SYNOPSIS OF PROFESSIONAL STAFF COMMENTS FOR PLANNING COMMISSION & CITY COUNCIL

Lot 1 and Outlots A & B, Springfield Industrial

**Arun Agarwal (Owner)/Tribedo LLC (Subdivider)/Thompson Dreessen & Dorner (Agent)
Final Plat Application**

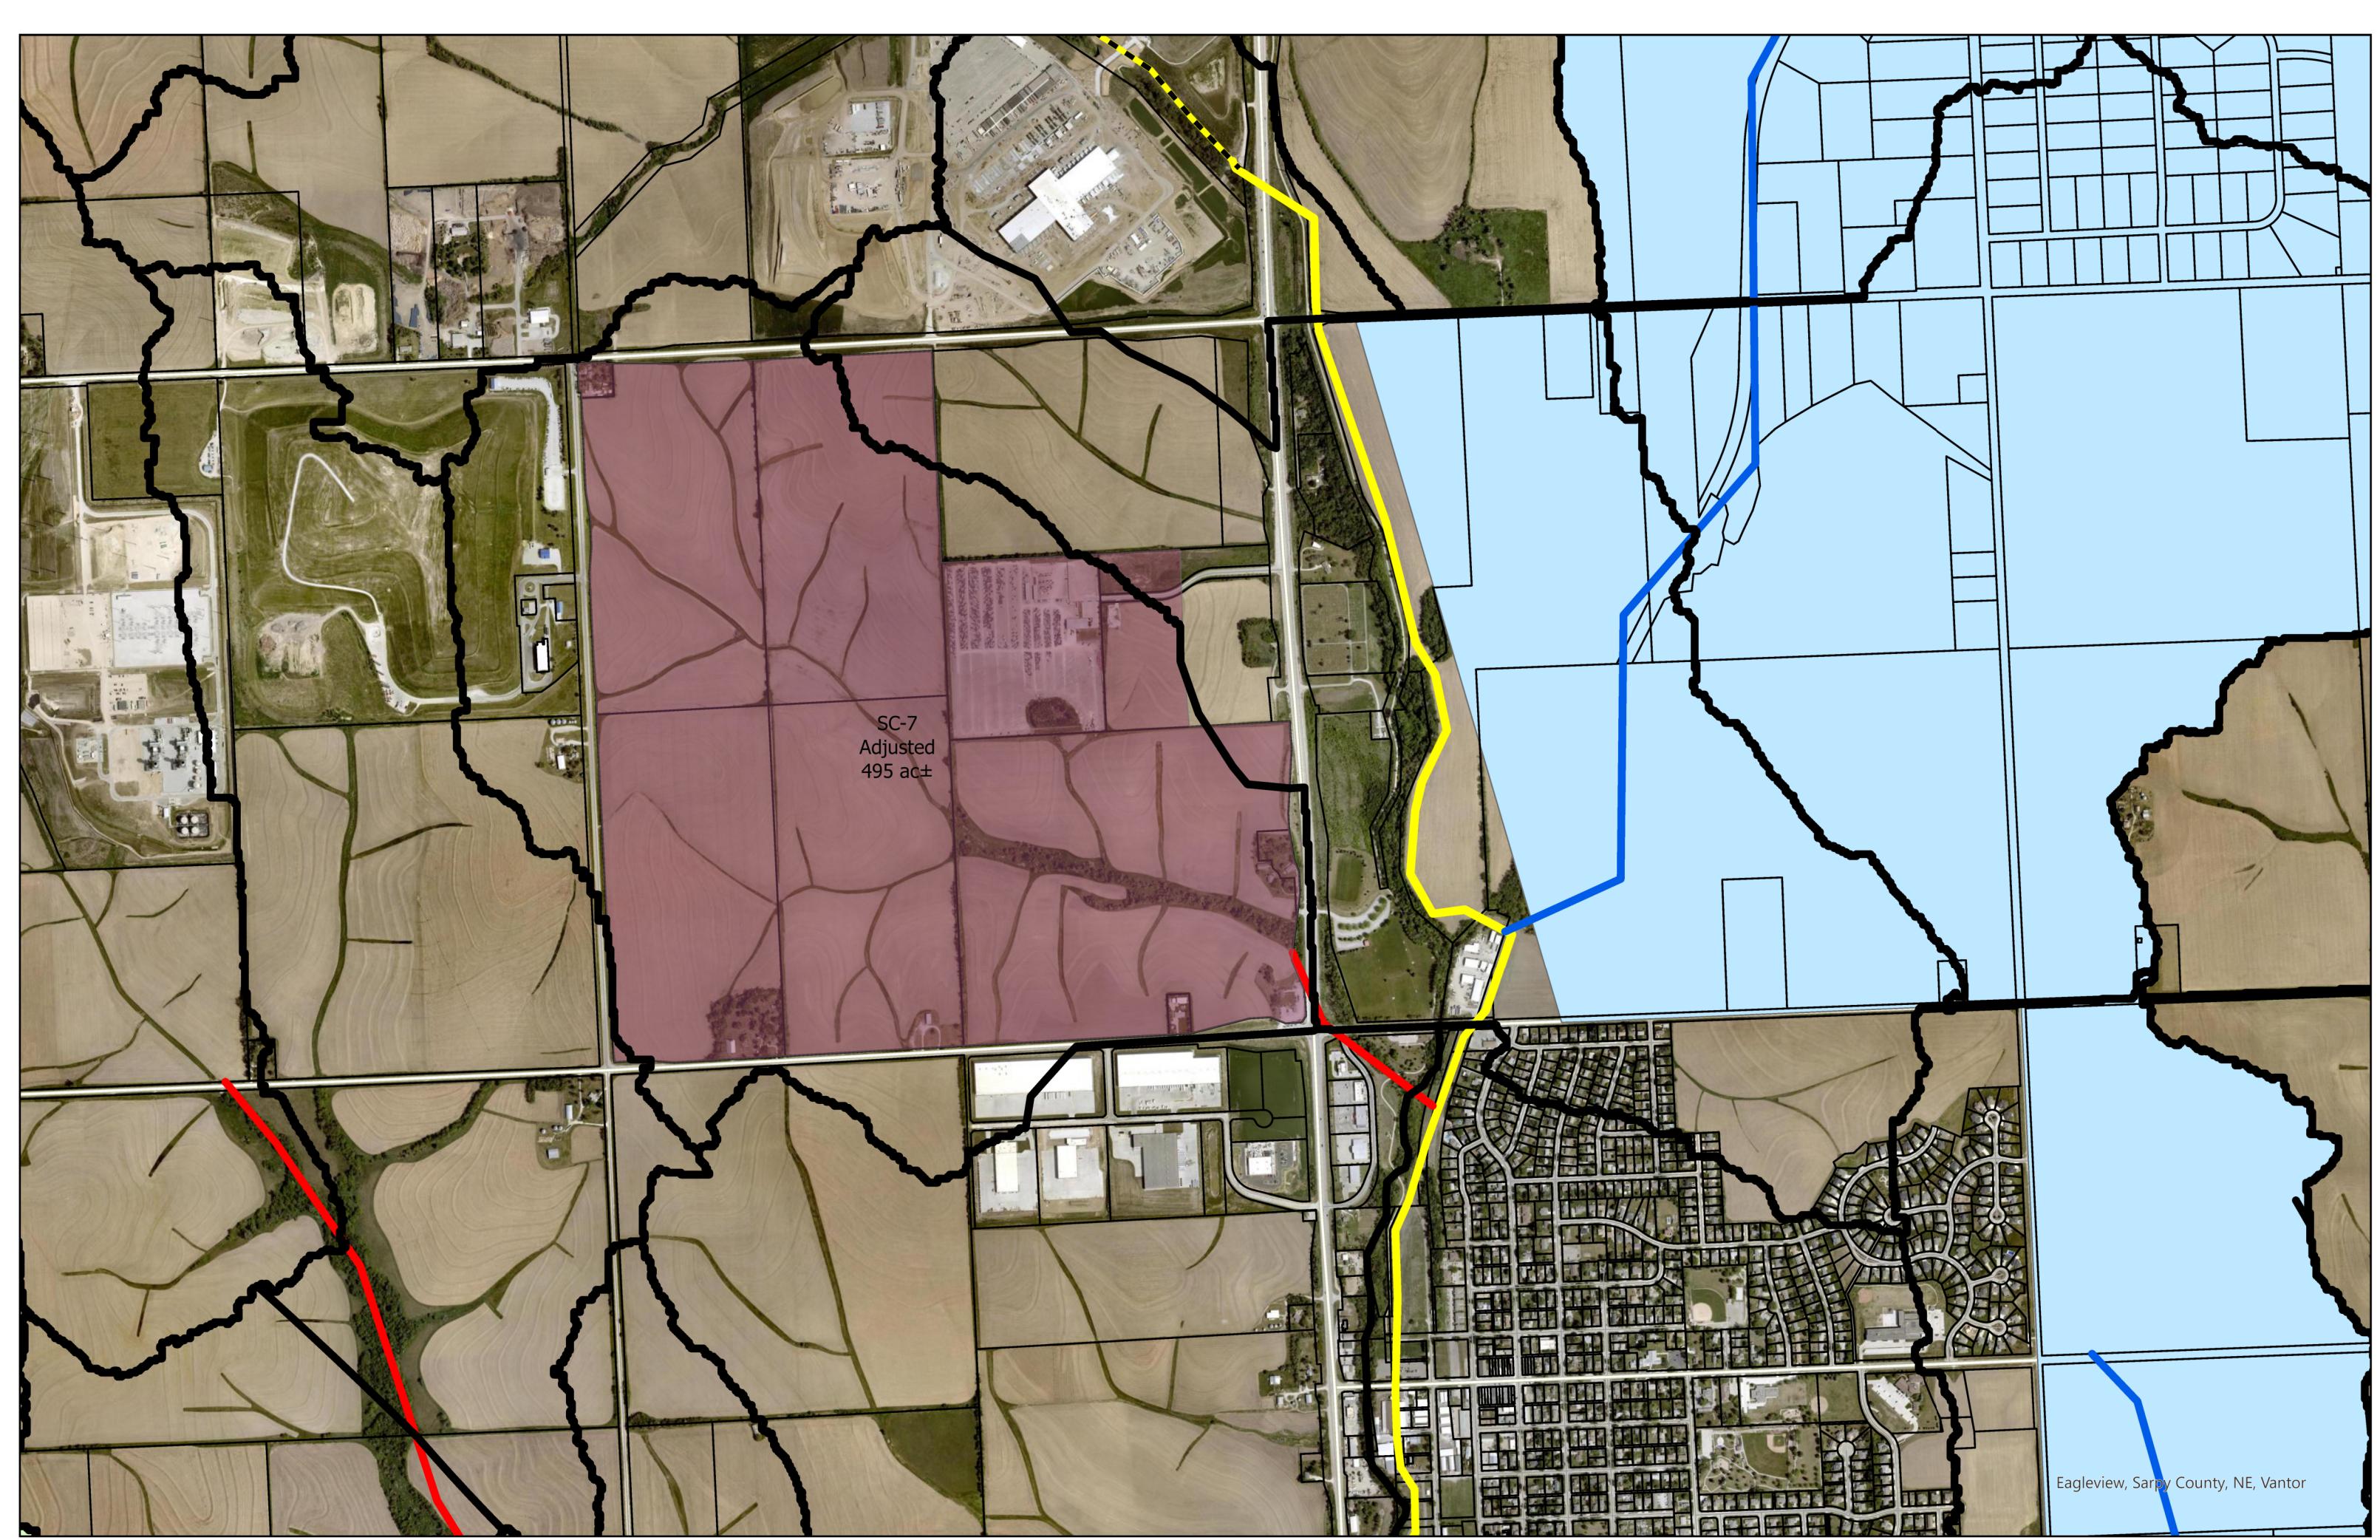
1. Recommend a boundary adjustment application be submitted to the Agency board to consider amending and adjusting the phase boundary of the current Master Plan to include the entire parcel within the Phase 1A service area since the entire parcel is proposed to be serviced by Phase 1A. Considering the proposed extension of the localized outfall sewer to this development area bisects nearly the entire SC-7 subbasin, it may be prudent to include all of SC-7 into the Phase 1A service area.

- a. Based on the current Agency Master Plan and the natural topography of the property, approximately 11 acres of the northeast corner of the parcel lies within the Phase 1A service area and the balance of the property, approximately 67 acres, lies within the “Long Term/Future” service area of the Agency. The “Long Term/Future” service area, identified in the Preliminary Engineering Report (PER) dated March 26, 2019 and revised November 23, 2020 is also referred to as Phase 3. While no formal or definitive timeline has been established for Phase 3 the PER suggested a design year of 40 years.

PLAN AND PROFILE STA 1056+00 TO STA 1070+00

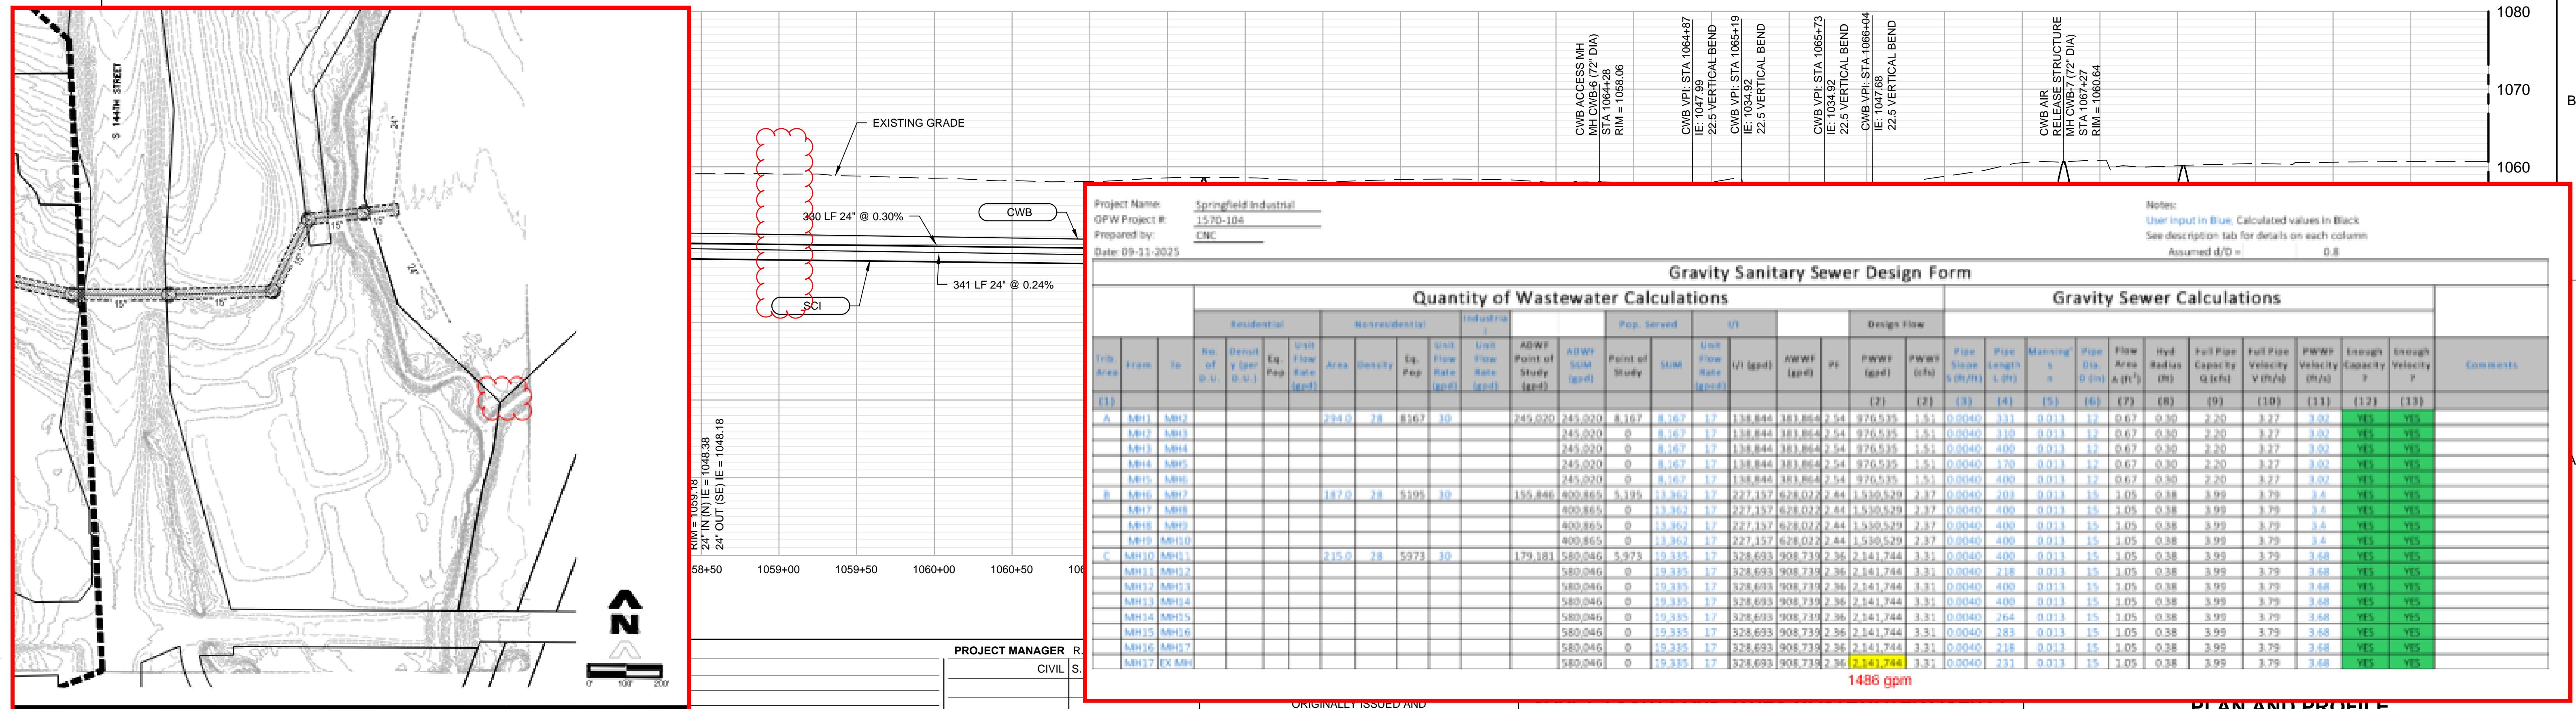
- i. This should be submitted and considered by the Agency board prior to final plat approval by the City of Springfield.
- 5. Upon further review of the Concept Refinement Basis of Design Technical Memorandum (TM), along with a consultation with HDR, there is not enough full flow design capacity at the proposed SCI manhole currently being shown however connection at or further downstream of SCI MH 18 would be permissible (**See attached HDR Review Sarpy Co Interceptor Combined Set 10-29-2021_jr.pdf**).

- a. Land uses from this development area were assumed “industrial” based on the future land use plans provided by the City of Springfield at the time of the Agency’s initial system design. The estimated flow rate for that land use was approximately 1,879 GPD to the SC-3 subbasin and 62,408 GPD to the SC-7 subbasin. <https://scacwa.maps.arcgis.com/apps/instant/basic/index.html?appid=6307929e69234ac58f8eb18b6e533fda>.

- b. Based on the current proposed layout, all flow from this development is being proposed to flow through the SC-7 subbasin generating a total proposed peak design flow of 2.14 MGD for the entire SC-7 subbasin. The TM for the Springfield Creek Interceptor Sewer (SCI) dated November 19, 2020 estimated approximately 2.18 MGD from Subbasin SC-7; however, its connection to that interceptor was proposed approximately 2,270 LF further south than the current proposed connection location.

SPRINGFIELD,
NEBRASKA
SARPY COUNTY
FINAL PLAT
Sheet Number
SHEET 1 OF 1

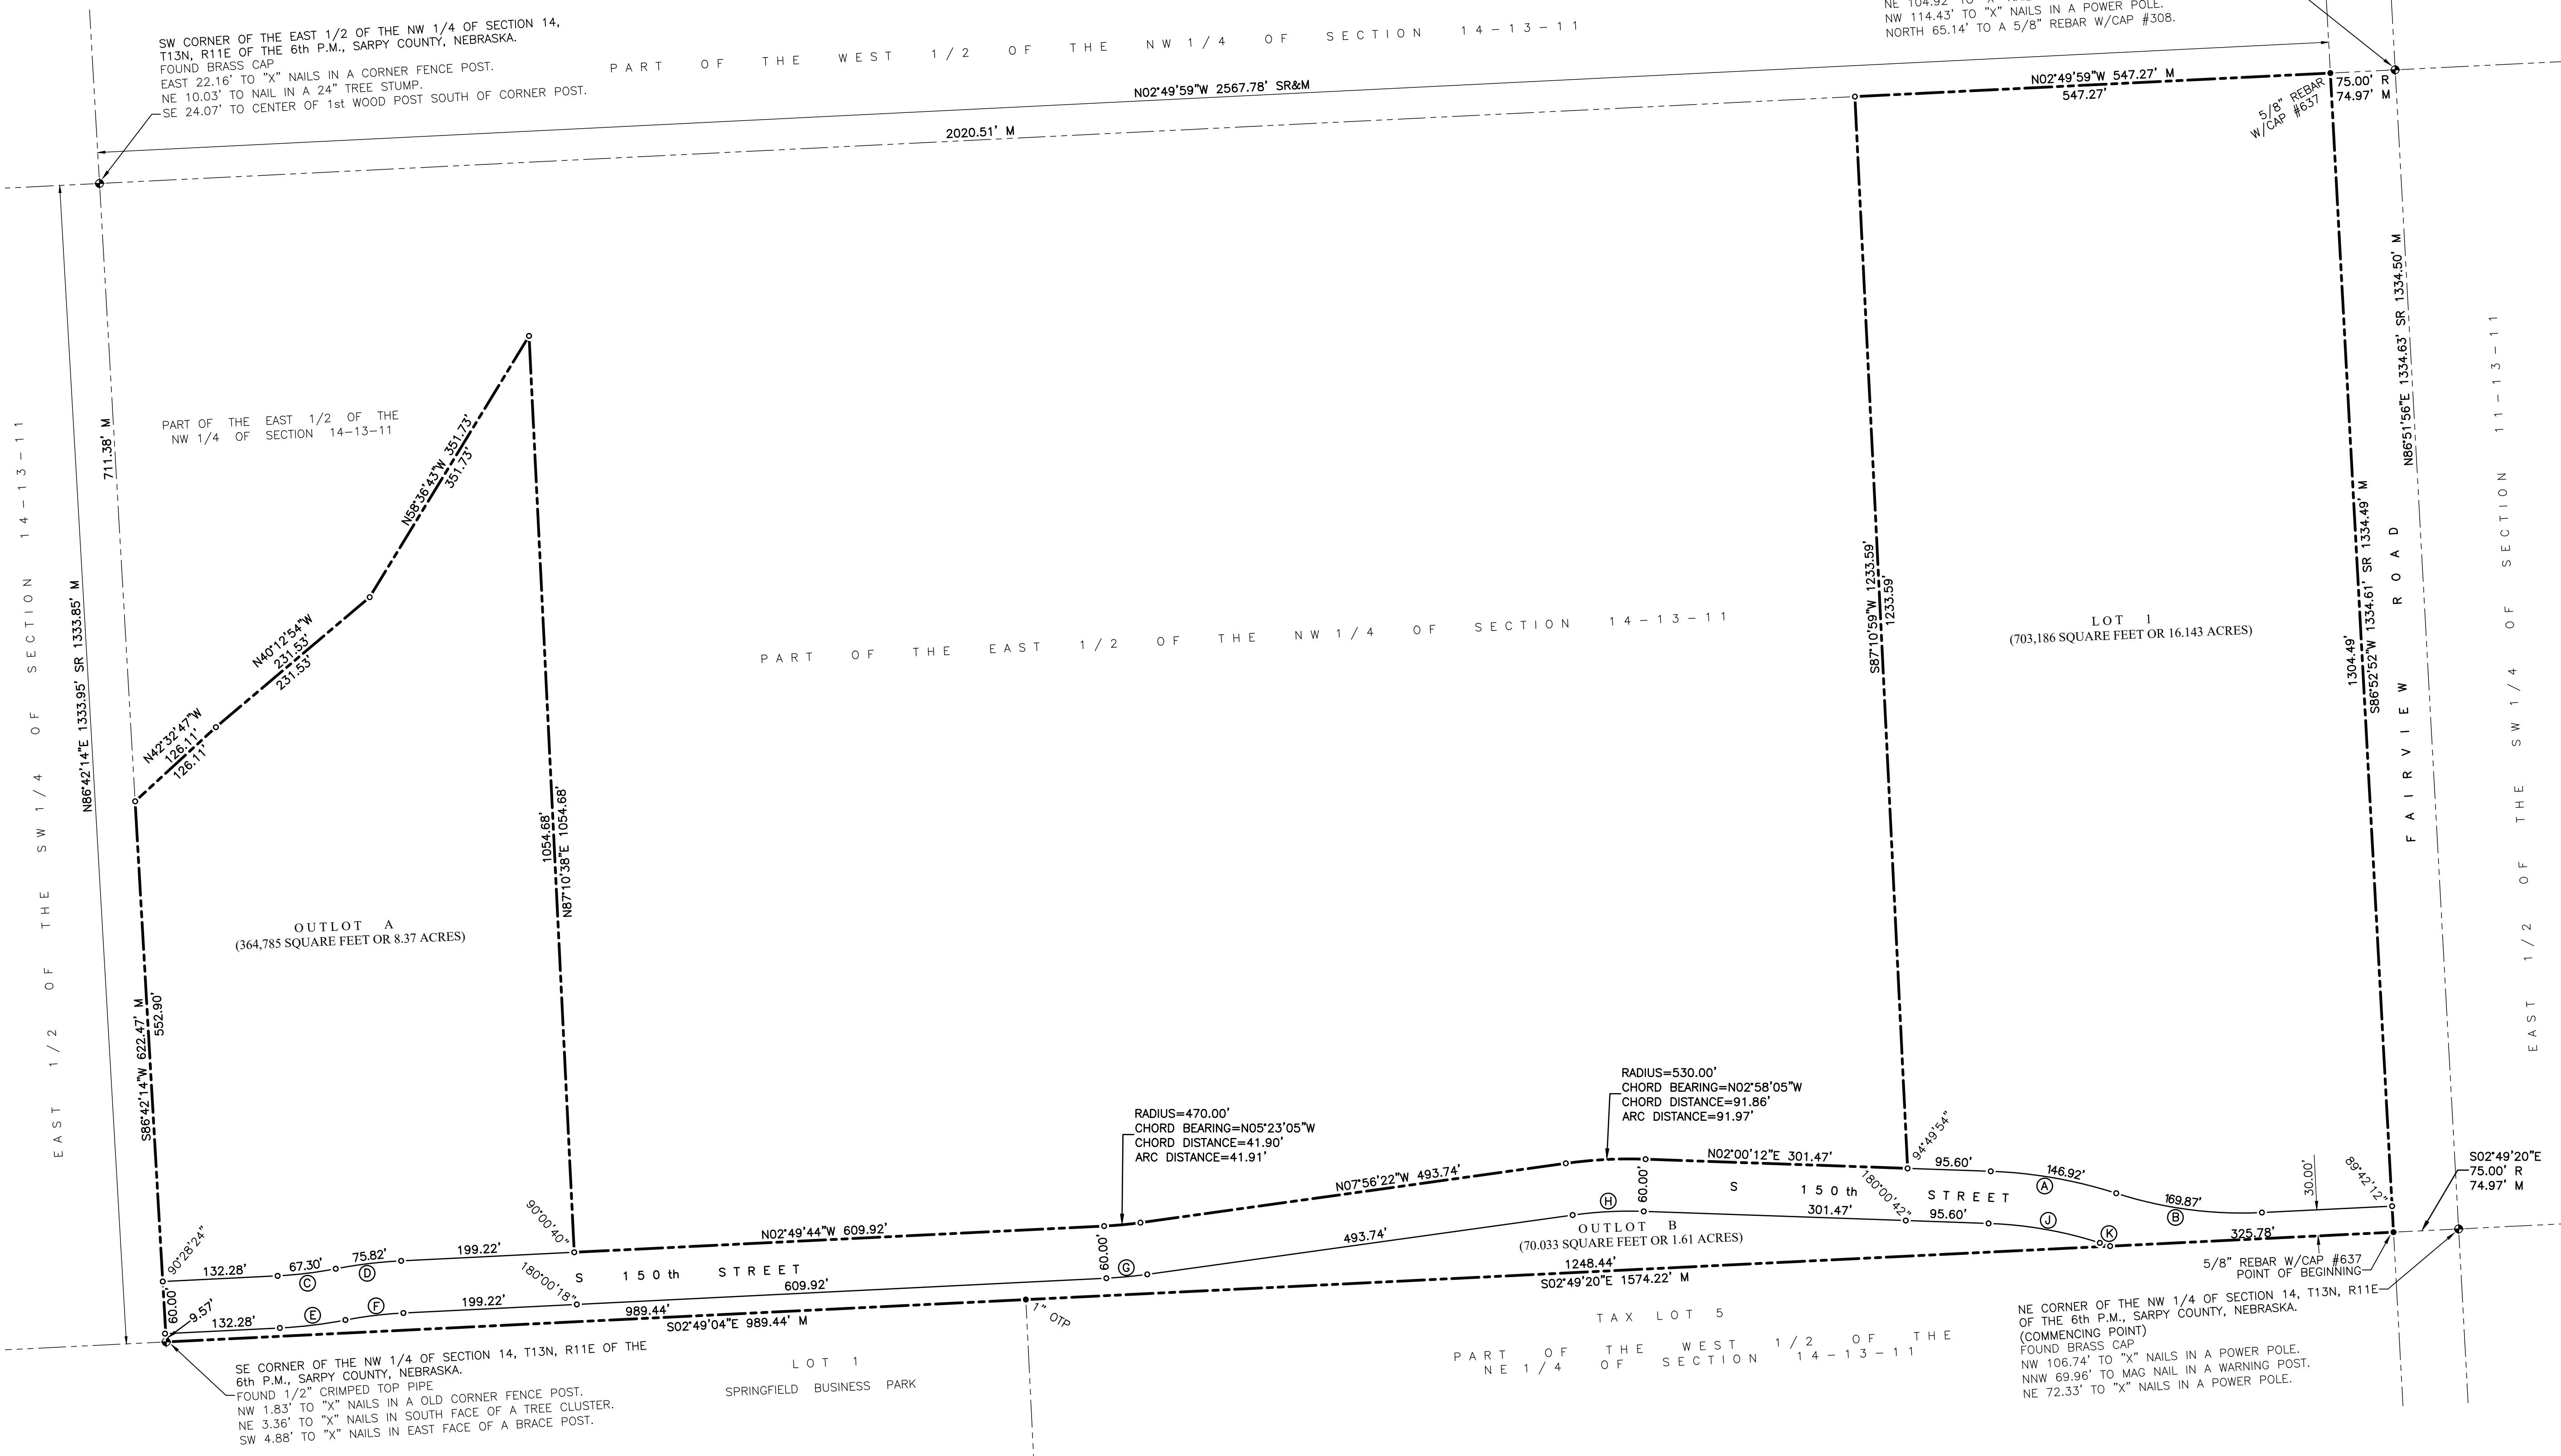
1. The second paragraph in the Surveyor's Certificate states "THENCE S0°249'20"E (ASSUMED BEARING) 74.97 FEET ON THE EAST LINE OF THE NW 1/4 OF SAID SECTION 14 TO THE SOUTH RIGHT OF WAY LINE OF FAIRVIEW ROAD AND THE POINT OF BEGINNING;
 - a. Agent to replace ASSUMED BEARING with ASSUMED FROM STATE PLANE? 2° TWIST.
2. Agent to indicate survey type under Agent name and address in upper right-hand corner.
 - a. (See attached **ACTUAL FINAL PLAT - Springfield Industrial Final Plat-A1570-104A(Comments) 12-16.pdf.**)
